AGENDA

The Columbia Architectural Design Review Team will meet on Tuesday, June 7th, 2022 at 8:00 a.m. in Conference Room A on the basement level of City Hall, 700 N. Garden Street to consider the following:

8:10 AM 22-0119 - 2008 Main Street - Modify Façade Of Existing Building
Request from Richard Thompson on behalf of Ritco Group, Inc for façade
modifications at [2008 S. MAIN STREET.](#)

GHOLAMREZA EBRAHIMZADEH
 TOP TIRE SHOP
 1002 CARMACK BOULEVARD, COLUMBIA,
 TN 38401
 EXISTING CONDITIONS

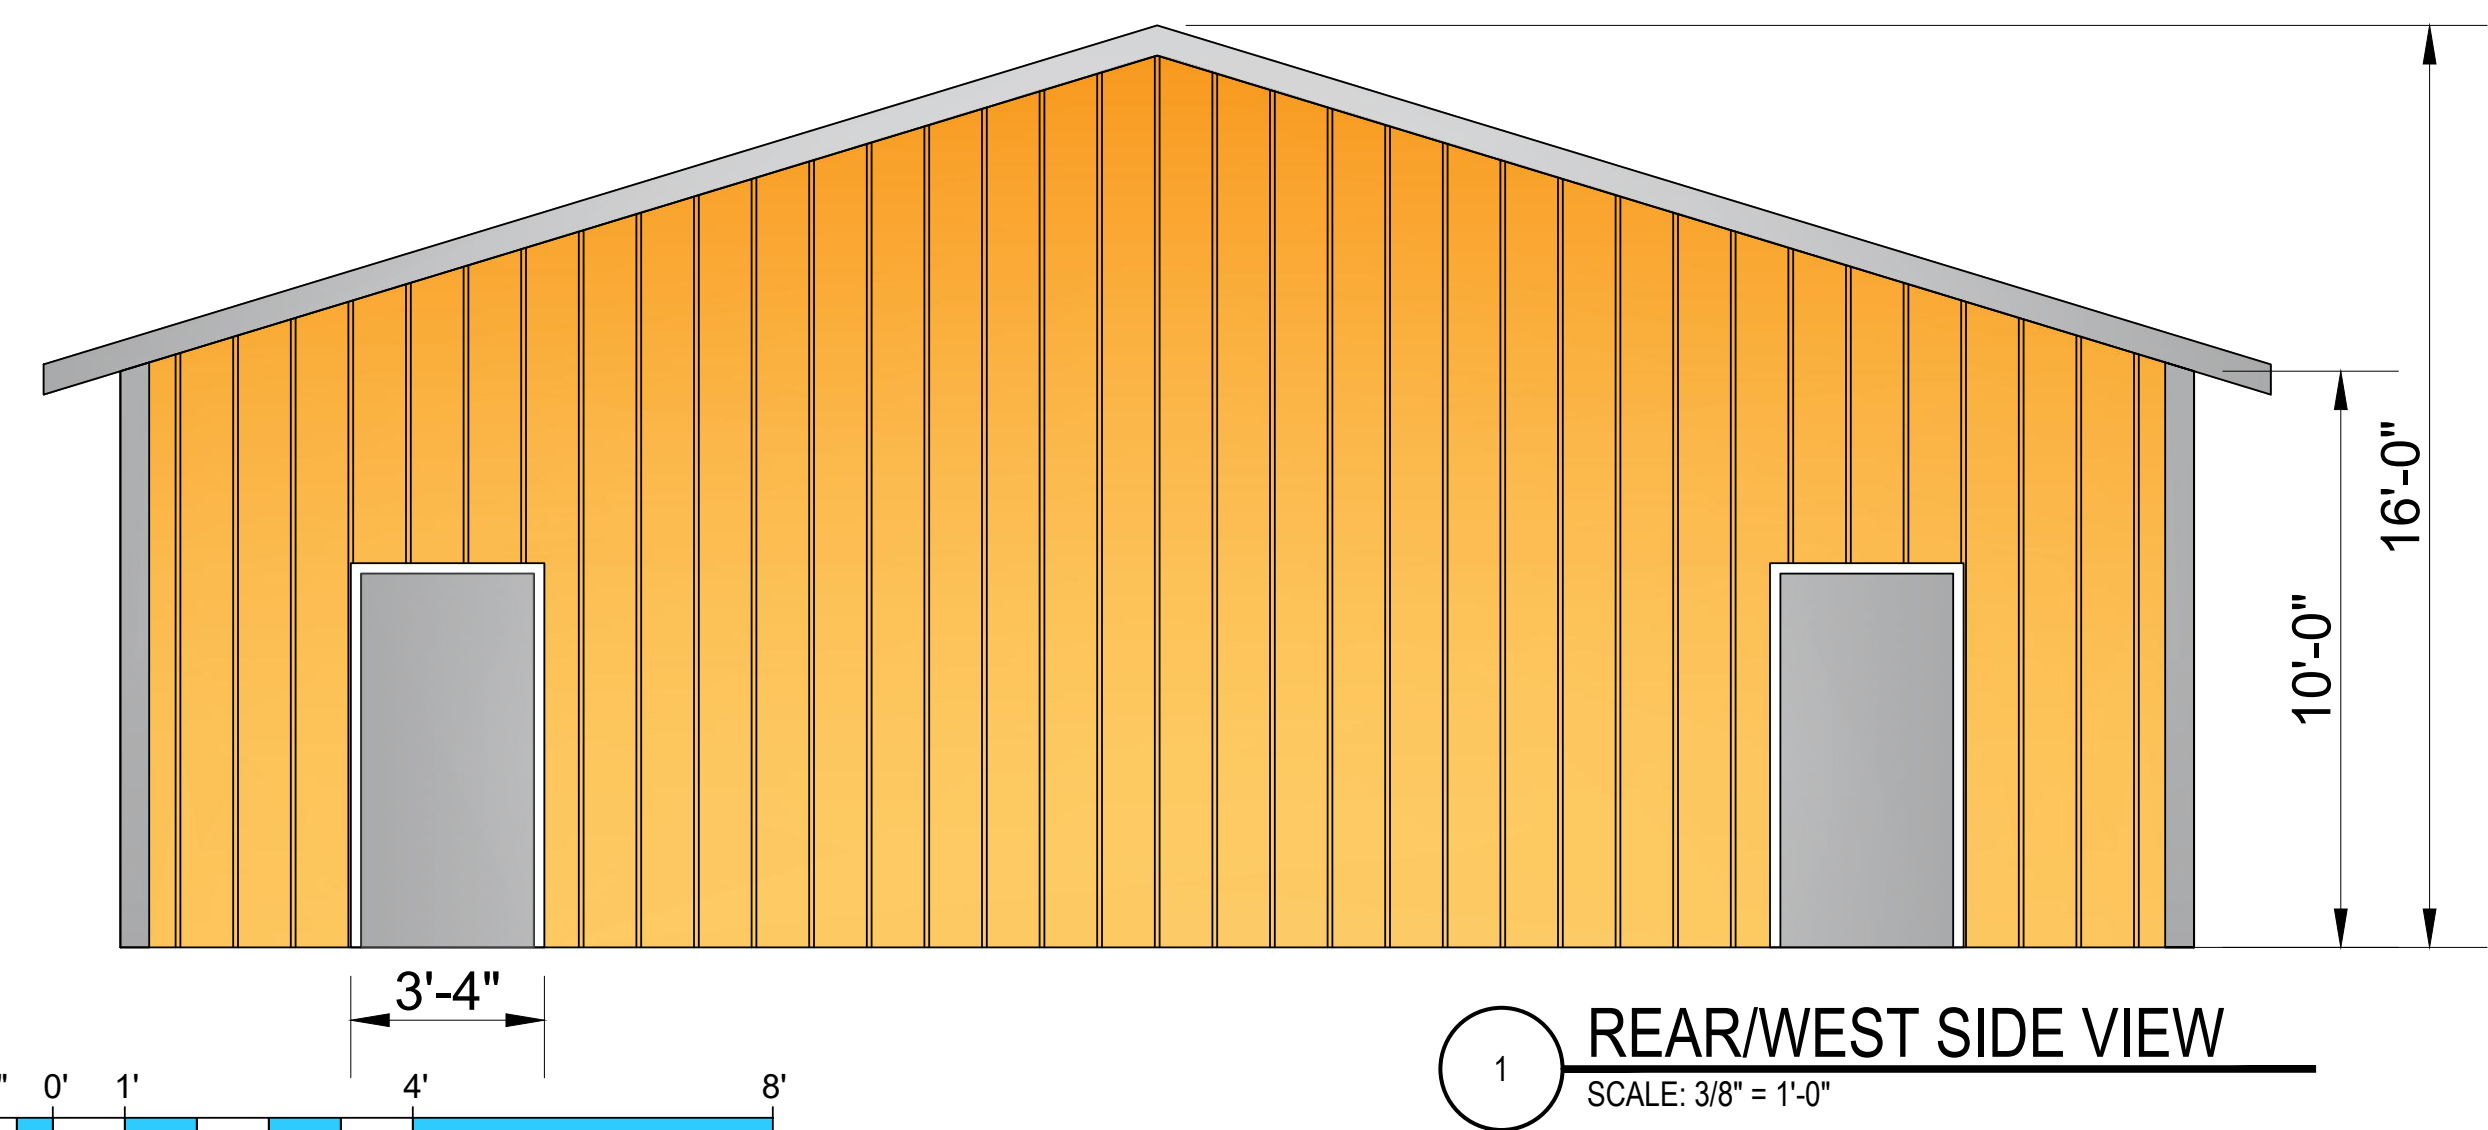
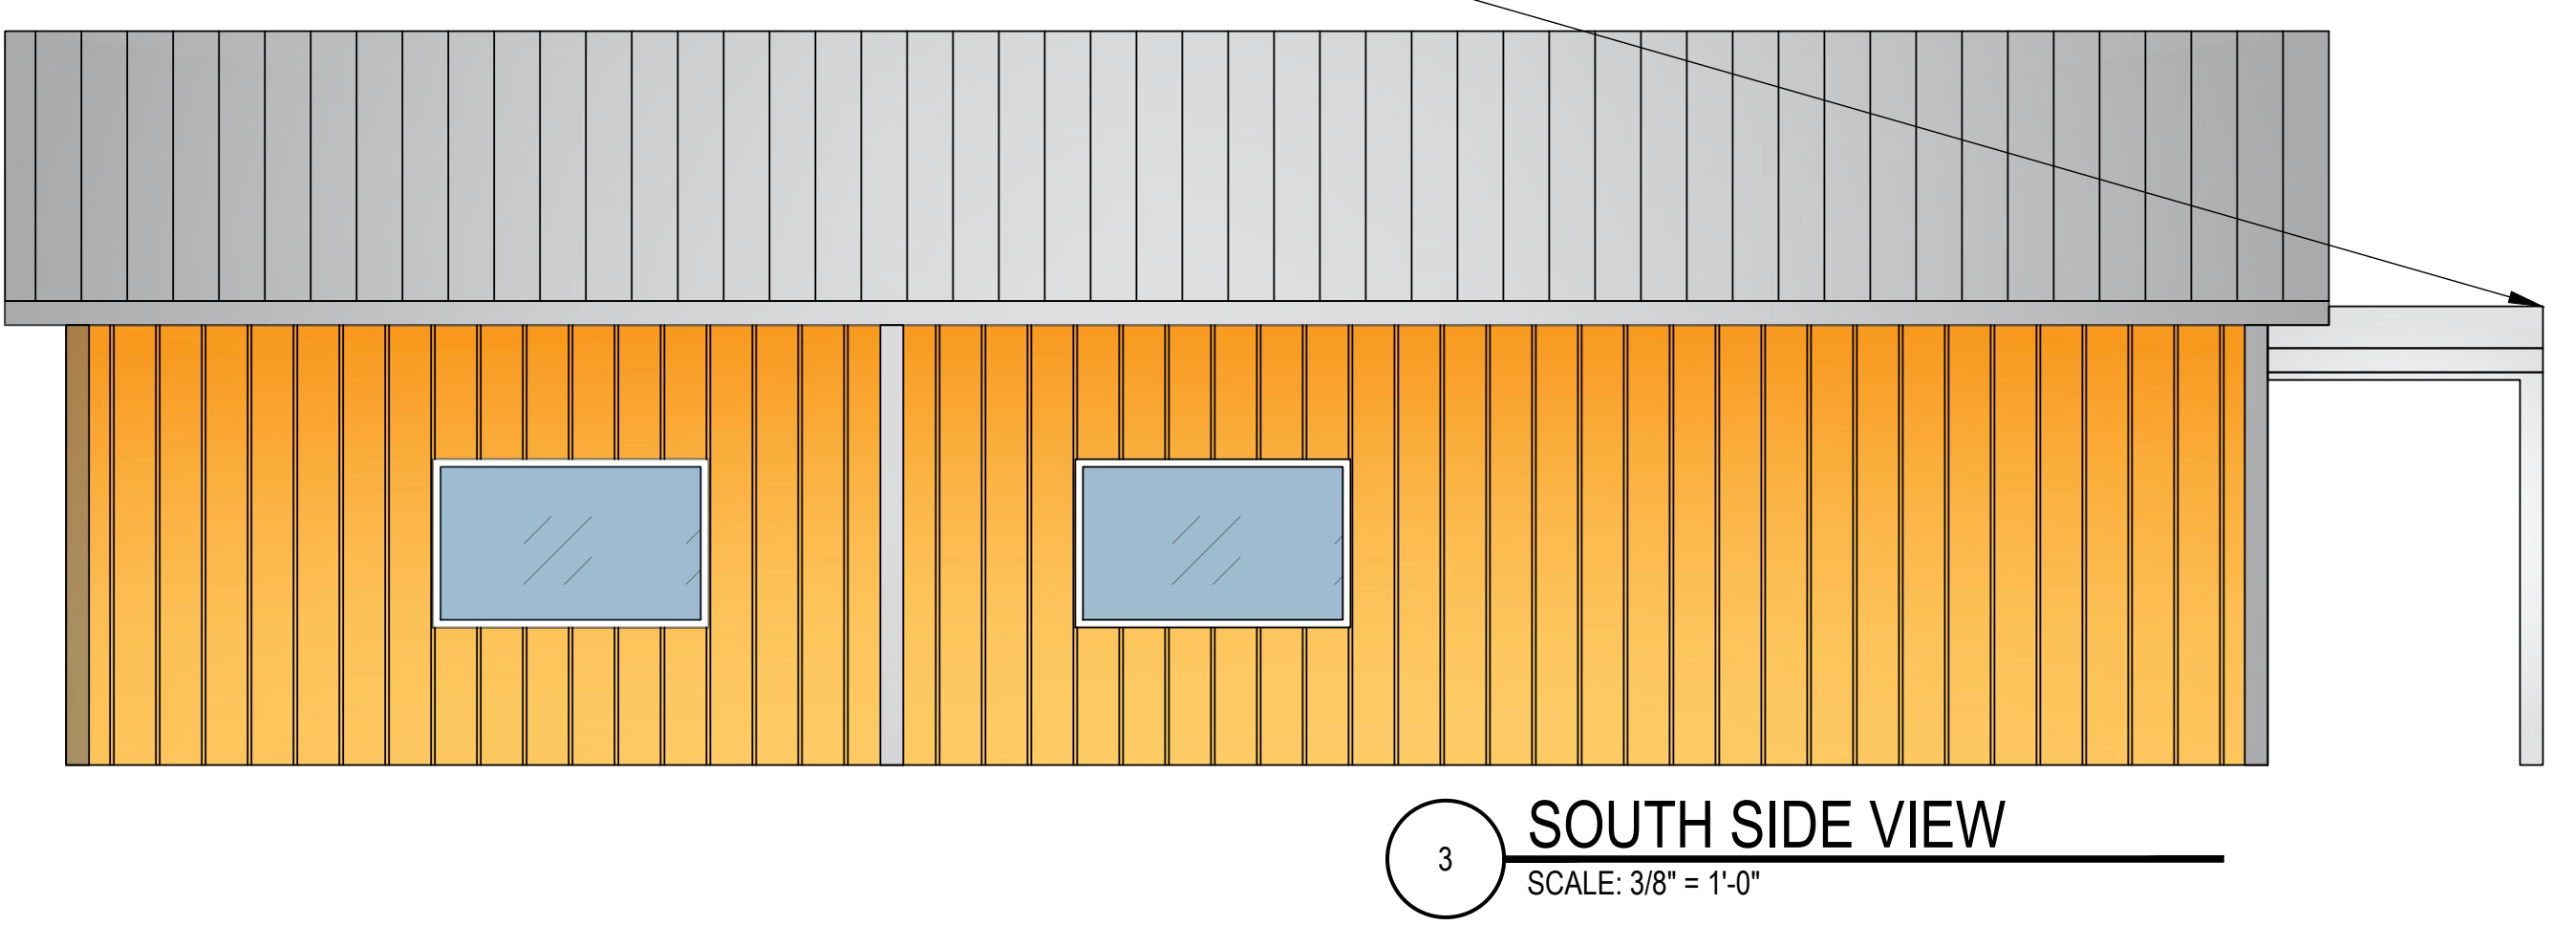
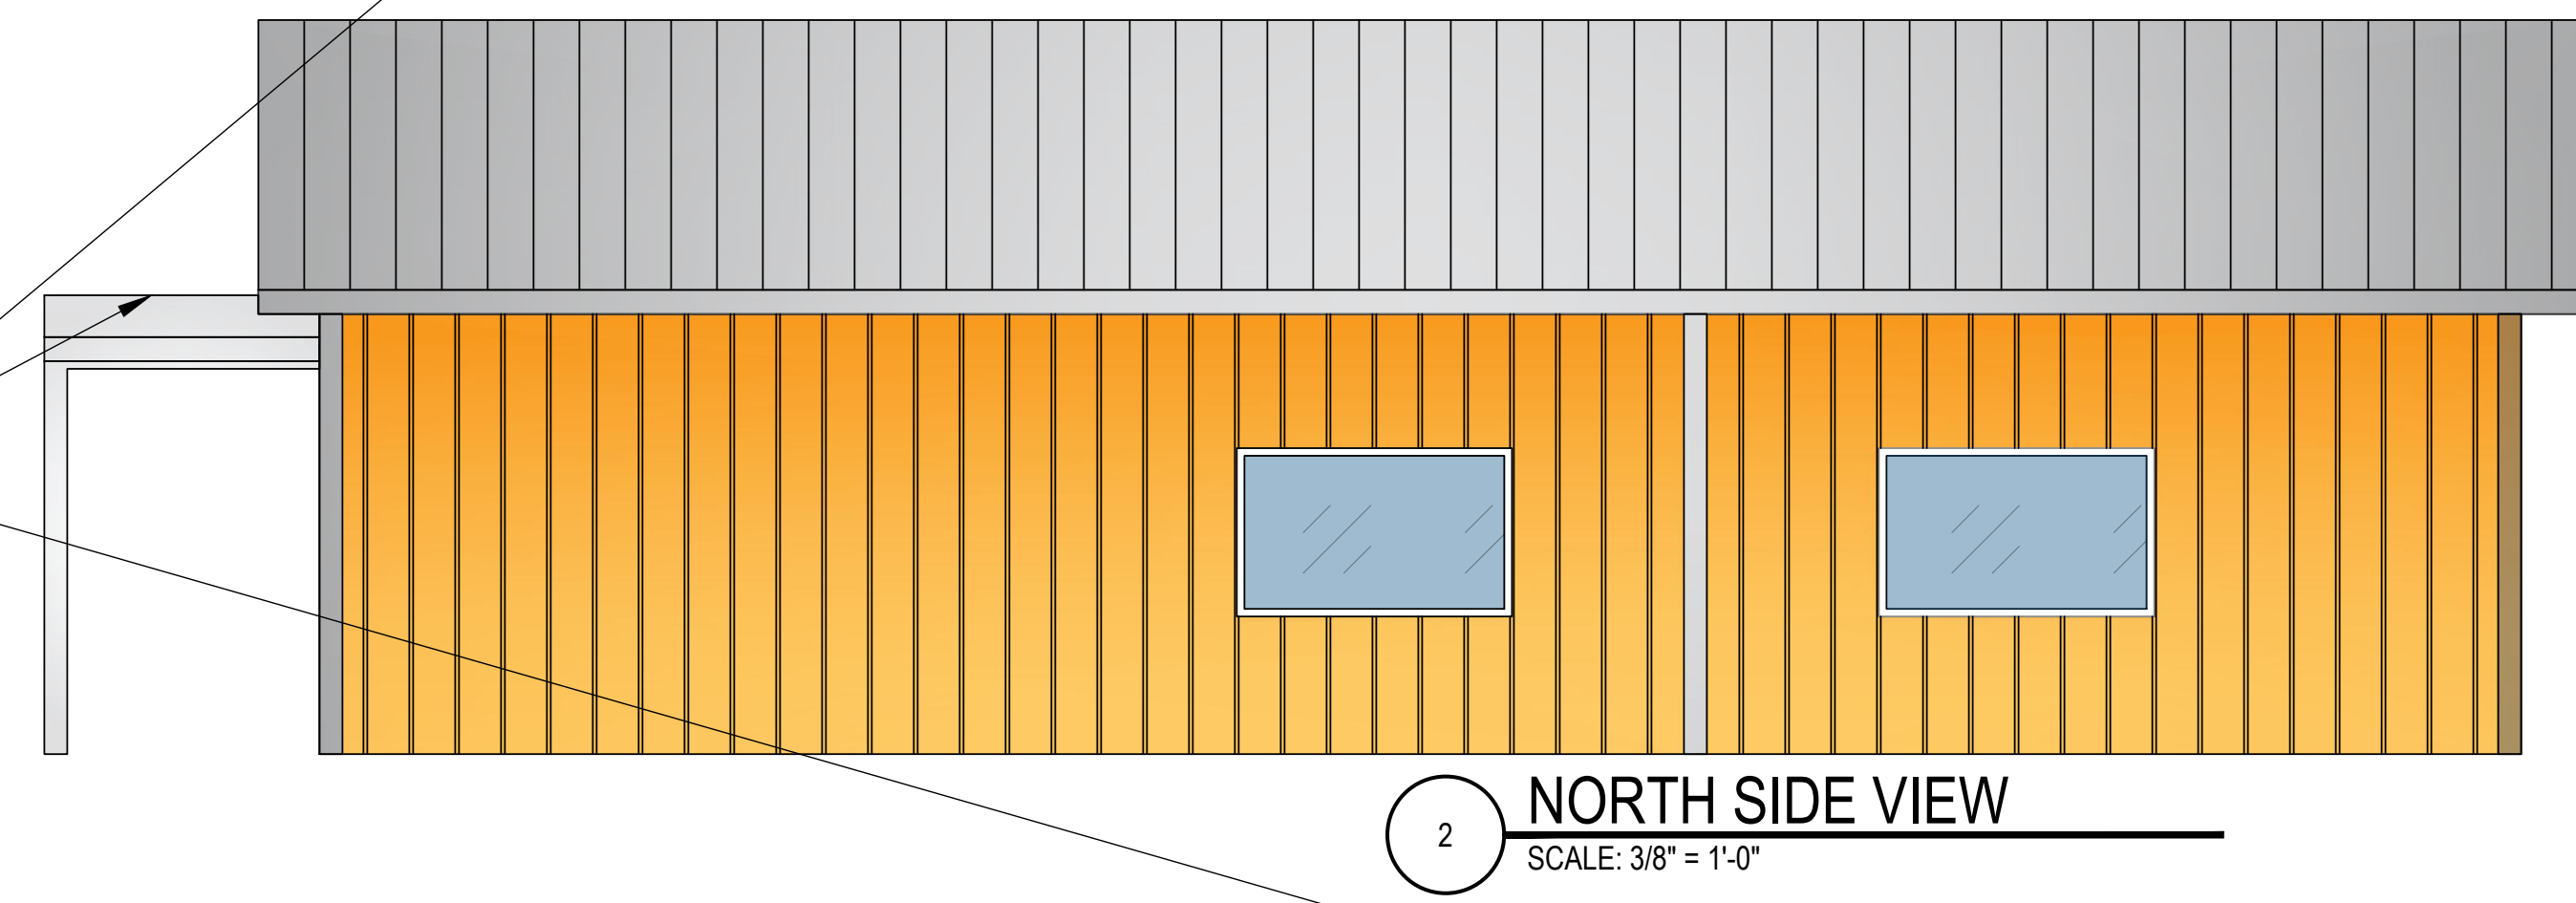
This request is for a minor façade modification for the removal of an existing window area for the placement of a 10 X 9 garage door opening that will serve a proposed new use of a tire shop.
